From: WILLIFORD Dennis (AREVA) [Dennis.Williford@areva.com]
Sent: Thursday, August 02, 2012 12:10 PM
To: Tesfaye, Getachew
Cc: BENNETT Kathy (AREVA); DELANO Karen (AREVA); ROMINE Judy (AREVA); RYAN Tom (AREVA); KOWALSKI David (AREVA)
Subject: Response to U.S. EPR Design Certification Application RAI No.462, FSAR Ch. 6, Supplement 5
Attachments: RAI 462 Supplement 5 Response US EPR DC.pdf

Subject: Response to U.S. EPR Design Certification Application RAI No.462, FSAR Ch. 6, Supplement 4

Question 06.04-7:

Figure 9.4.1.1—Control Room Air Intake and CREF (Iodine Filtration) Train Subsystem

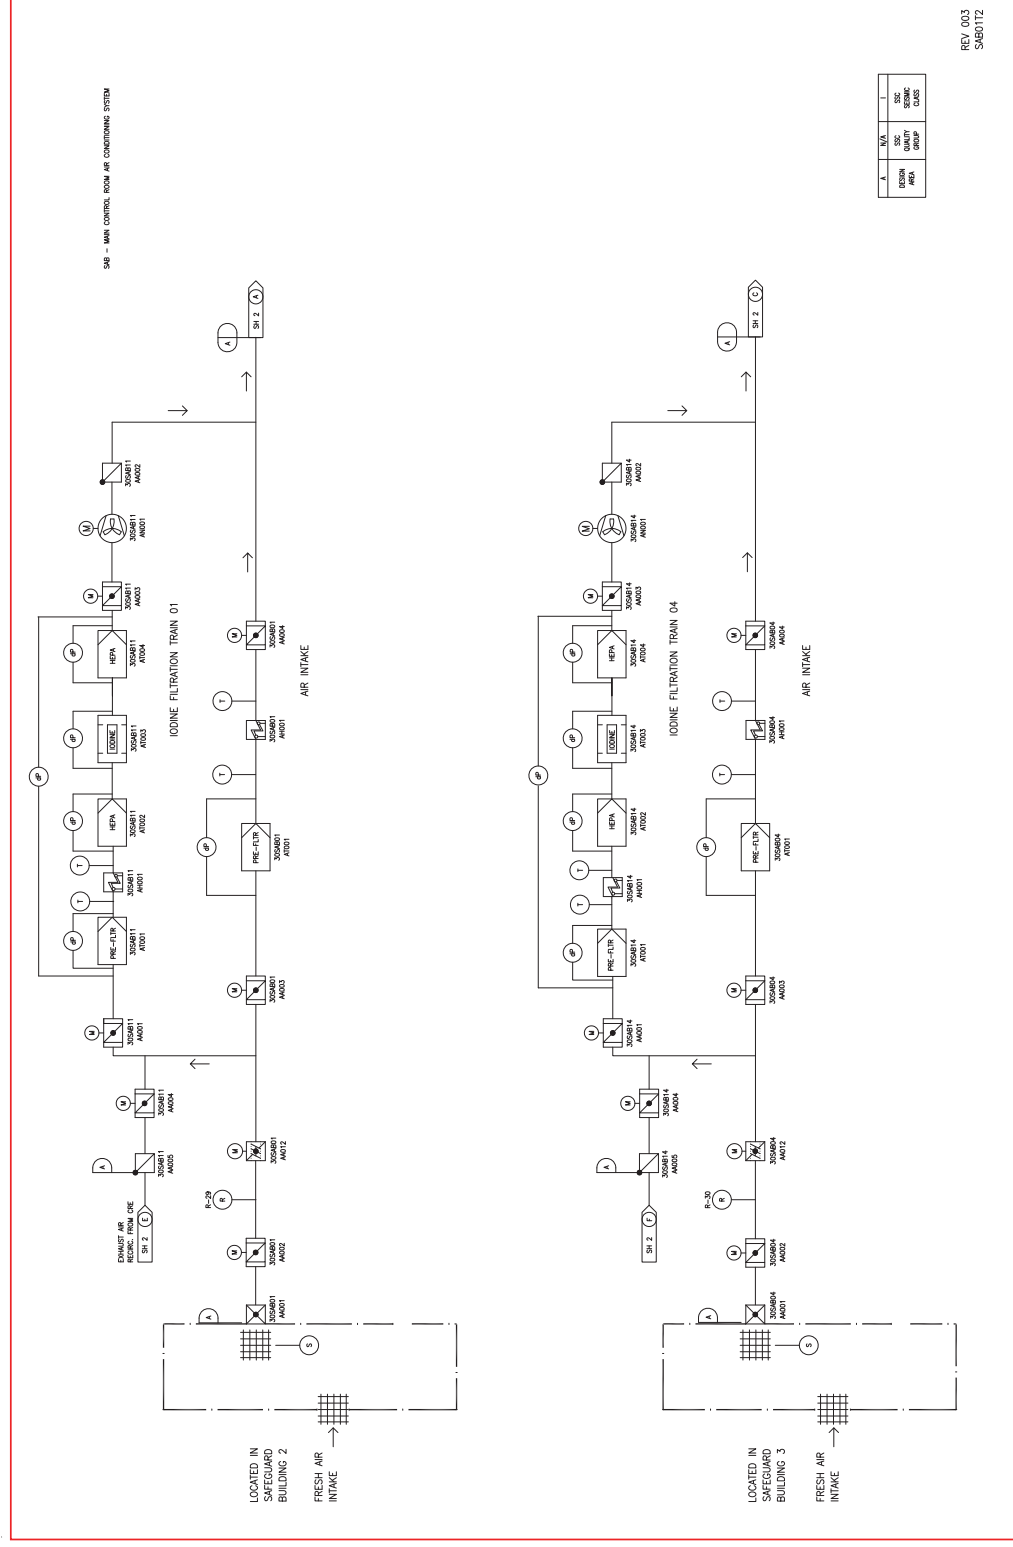
Because toxic gas is site-specific, hardware associated with detection, measurement, and isolation are usually designated the responsibility of the COL and based on the specific toxic gas threat. The EPR design chooses to include some of the design information in the FSAR. Although this approach is not prohibited, addressing all possible toxic gas threat in the FSAR can be a challenge. In Tier 2 Section 6.4.2.4, the revised CRE design was changed to prescribe manual as opposed to automatic isolation of the CRE upon detection of toxic gas. If you choose to address toxic gas in the standard design FSAR, clarification of the following information in the FSAR is needed to make a regulatory finding.

- g. FSAR section 6.4 does not define or discuss zone isolation as covered in SRP 6.4 Section III.3.E.i, ii, iii, and iv. Provide a discussion in FSAR section 6.4 on how the EPR CRE addresses this guidance as it relates to the ventilation system types iii and iv and the method of operation for radiological and toxic gas events.

The U.S. EPR FSAR has been revised to reflect that a toxic gas event is a site-specific event. The equipment used for the detection, measurement and isolation associated with a toxic gas release are the responsibility of the COL applicant. The specific toxic gas design, which is

currently part of the design of the control room air conditioning system (CRACS) in the U.S. EPR standard design, has been removed from the CRACS, and applicable U.S. EPR FSAR Tier 1 and Tier 2 sections will be revised to reflect this change.

The following U.S. EPR FSAR Tier 2 sections were revised in Revision 3 to reflect the removal of the toxic gas design from the U.S. EPR standard CRACS design:

- Figure 9.4.1-1—Control Room Air Intake and CREF (Iodine Filtration) Train Subsystem).
